Subdivision Authority

File No. LDA08-0155

RE: Tentative plan of subdivision to create 53 single-detached residential lots and one multi-family block shell from a portion of SE-19-53-25-4, located north of Yellowhead Trail and west of 199 Street; **BIG LAKE NEIGHBOURHOOD ONE**

I The Subdivision by Plan is APPROVED on September 25, 2008, subject to the following conditions:

SUBDIVISION CONDITIONS OF APPROVAL MAP

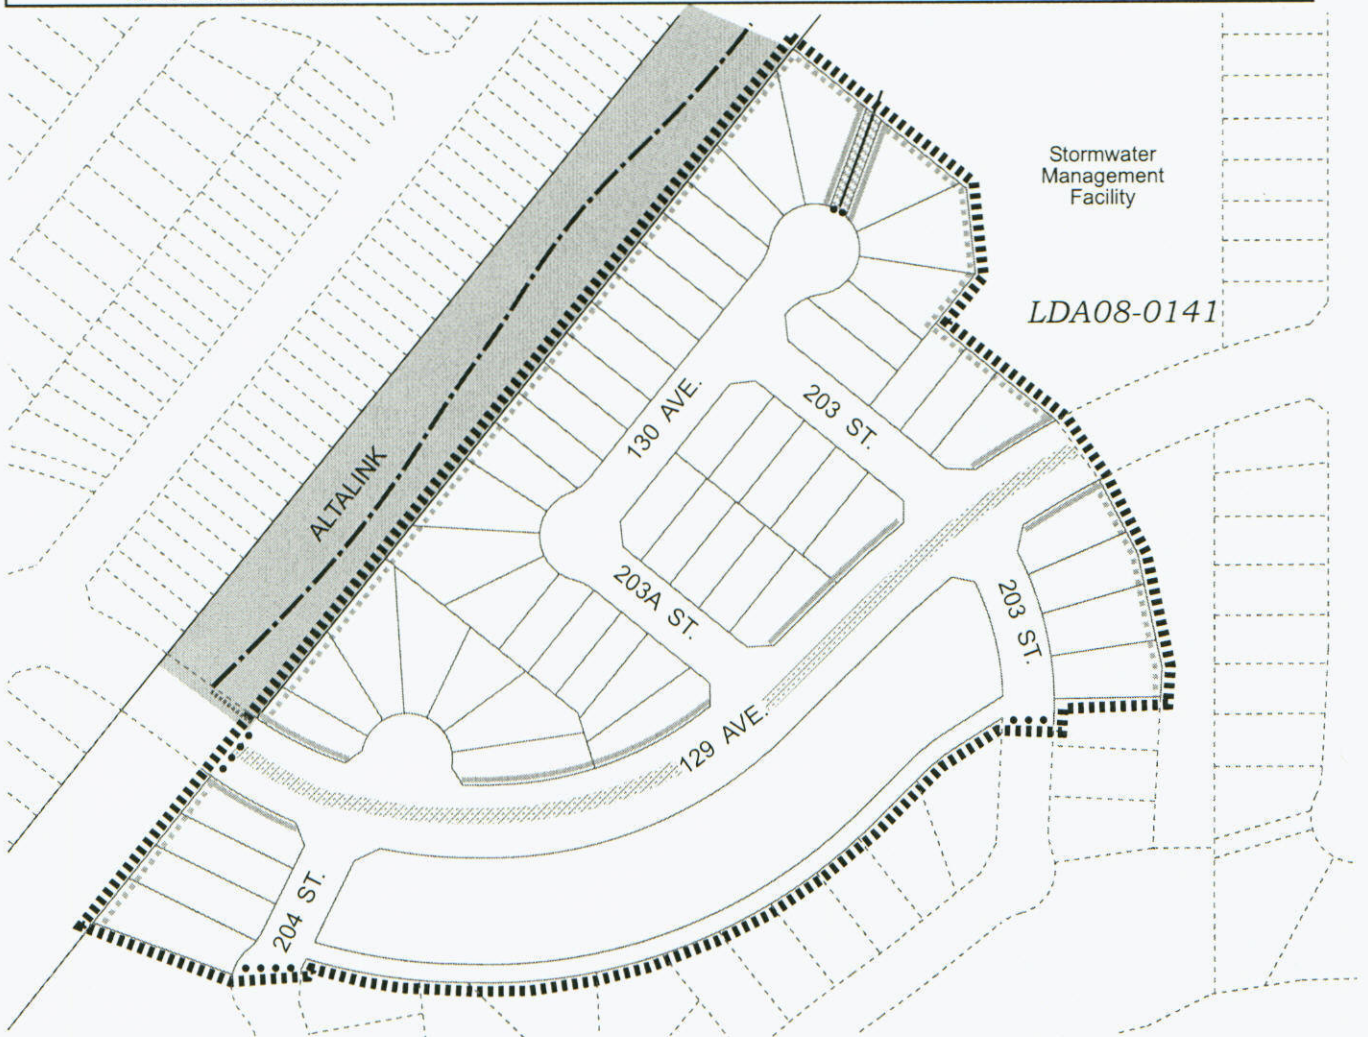
8. that the owner develop a design and cross-section for 129 Avenue to the satisfaction of the Transportation Department. The east-west collector roadway will have a unique design and is anticipated to incorporate median bioswales, as shown on the "Conditions of Approval" map, Enclosure I. The Transportation Department advises that access to RF5 lots fronting 129 Avenue must be limited to the rear alley;

9. that the owner construct a 3 m asphalt multi-use trail with a dividing yellow centreline and "Shared Use" signage within the power line right-of-way from 129 Avenue to the southwest corner of the storm water management facility, as shown on Enclosure I;

10. that a temporary sidewalk connection to the 3 m asphalt multi-use trail be provided on the north side of 129 Avenue at the west end of the subdivision, as shown on Enclosure I;

12. that the walkway in the north section of the subdivision contain a 1.5 m concrete sidewalk with bollards, lighting, and 1.8 m uniform fencing to be provided within residential property lines, as shown on Enclosure I. The sidewalk must be extended to tie into the granular trail along the public utility lot that will be constructed as part of LDA08-0141;

14. that the owner construct all fences positioned wholly on privately-owned lands to the satisfaction of the Transportation and Asset Management and Public Works Departments in the locations shown on Enclosure I.
